T&E COMMITTEE #2
March 1, 2012

MEMORANDUM

SUBJECT: FY13-18 Capital Improvements Program—transportation: Capital Crescent Trail project

CAPITAL CRESCENT TRAIL
CONSIDERATIONS FOR
MONTGOMERY COUNTY

3.1 Alternative A - The Locally Preferred Alternative

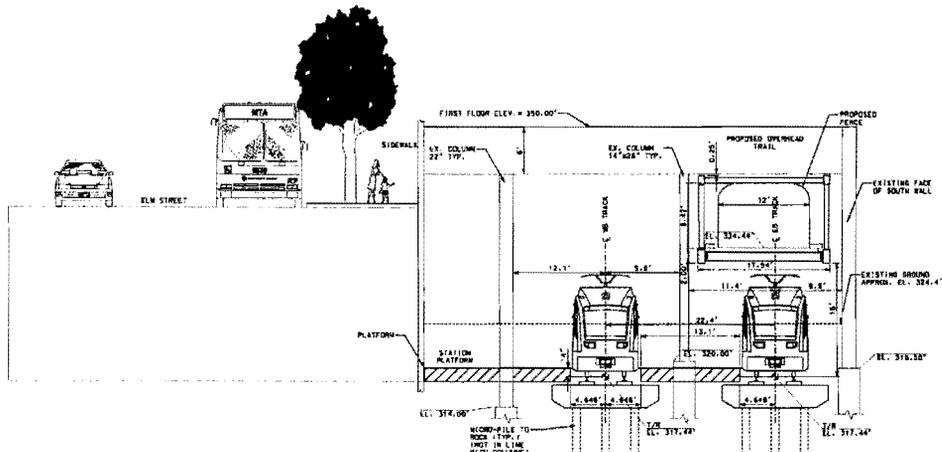
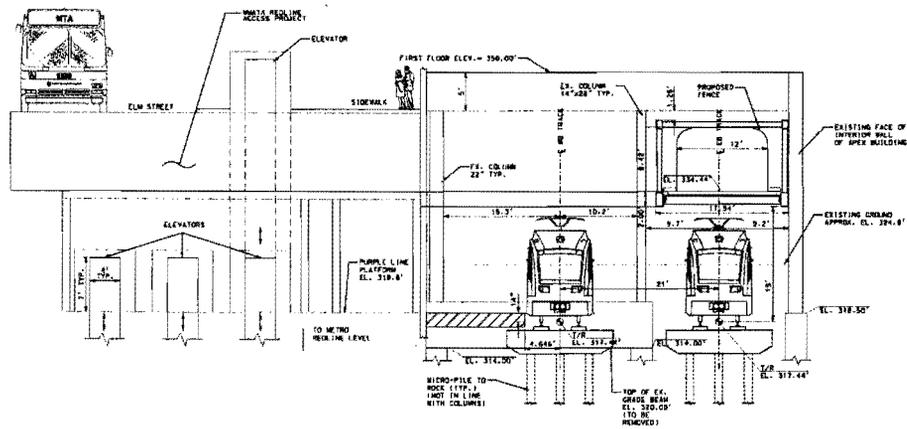
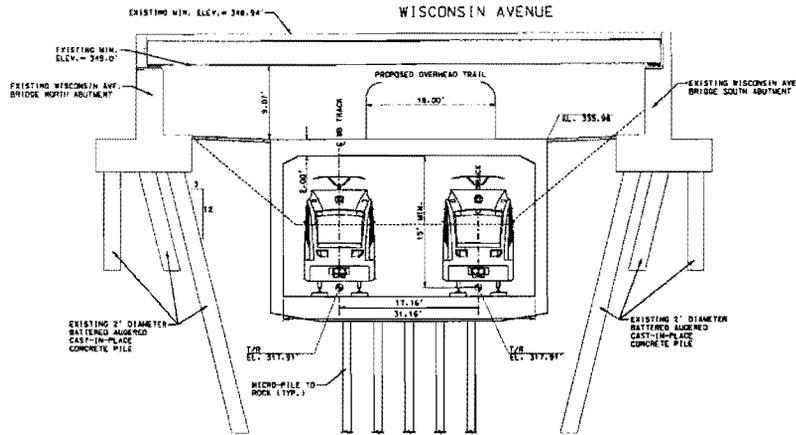
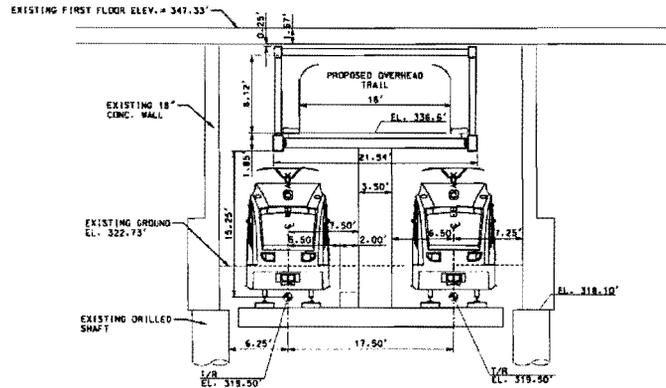
Last fall MTA presented its analysis of tunnel options to the Planning Board, noting that Route A1's trail-over-transit concept (Alternative A in MTA's report) requires excavating 8-10' beneath the ground level under the Apex Building and Wisconsin Avenue, costing about \$50 million more (in 2020 dollars) than if solely Route A2 were built (Alternative B). Furthermore, it would pose serious risks to the structural integrity of the Apex Building. The Planning Board's response was to request more options to be studied, including: relocating the station east of the Air Rights Building entirely, at the foot of Pearl Street and behind homes on Elm Street in the Town of Chevy Chase (Alternative C); and razing and rebuilding the Air Rights Building to create an envelope wide enough for two tracks, a station platform, and the trail (Alternative D).

Council staff's comments. Alternative A's \$47 million added cost to the Council is prohibitive, considering it is already, it may invest \$80.5 million for the Bethesda Metro Station's south entrance and at least \$48.1 million for the balance of the CCT between Bethesda and Silver Spring (see Council staff's recommendation, below). Constructing it would pose a substantial risk to the structural integrity of the Apex Building; MTA notes that "the costs of the modifications and the risks (structurally and due to the lost productivity/occupancy of the tenants) associated with the construction may exceed the appraisal of the existing building." Council staff concurs with MTA that Alternative A should be dropped from further consideration.

Figure 1 – Depiction of Average Horizontal Illuminance Only
(70 foot light pole spacing)

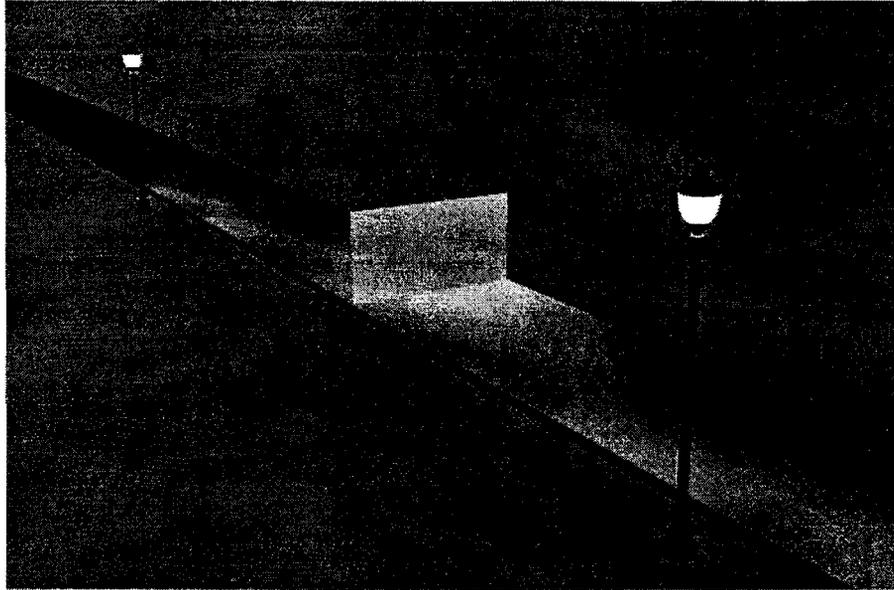
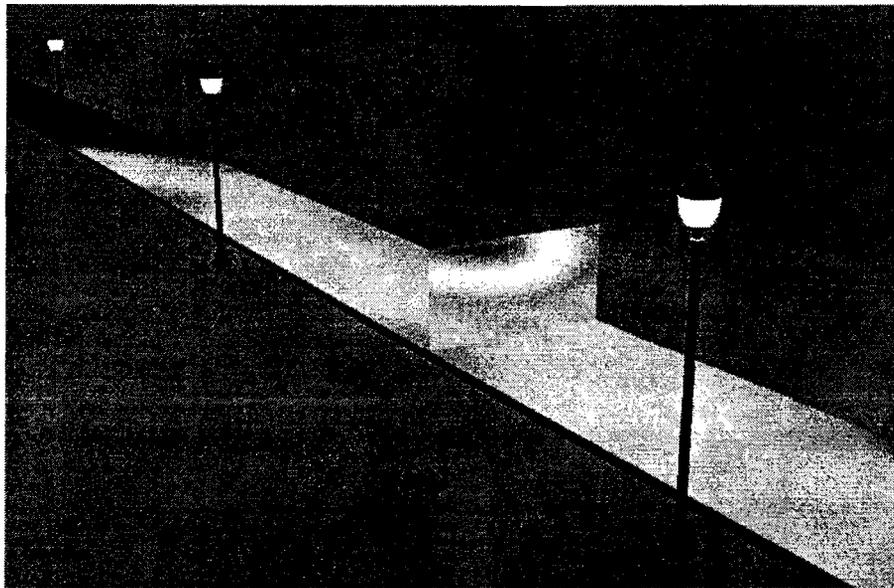
A convincing case for continuous lighting along the mainline of the trail has not been made. There is no continuous lighting on the CCT west of the Bethesda CBD, and while true that most park trails are closed at night, the CCT west of Bethesda is open for commuters. Bike commuters navigate the current trail quite well at night if their bikes have headlights. The cost to install continuous lighting is expensive, and it carries with it the ongoing operating cost for power and maintenance that the County would have to absorb. Lighting at some spots along the trail would be useful, however, especially at junctions with connecting paths and in the few underpasses. Rather than spending up to \$5.2 million for continuous lighting, including \$1 million in the project’s budget instead for spot lighting is more appropriate.

4. Provide continuous lighting on the Capital Crescent Trail between Bethesda and Silver Spring to the Illuminating Engineering Society of North America (IESNA) standard for vertical illuminance, and provide maximum protection for undesirable spillover onto adjacent properties.
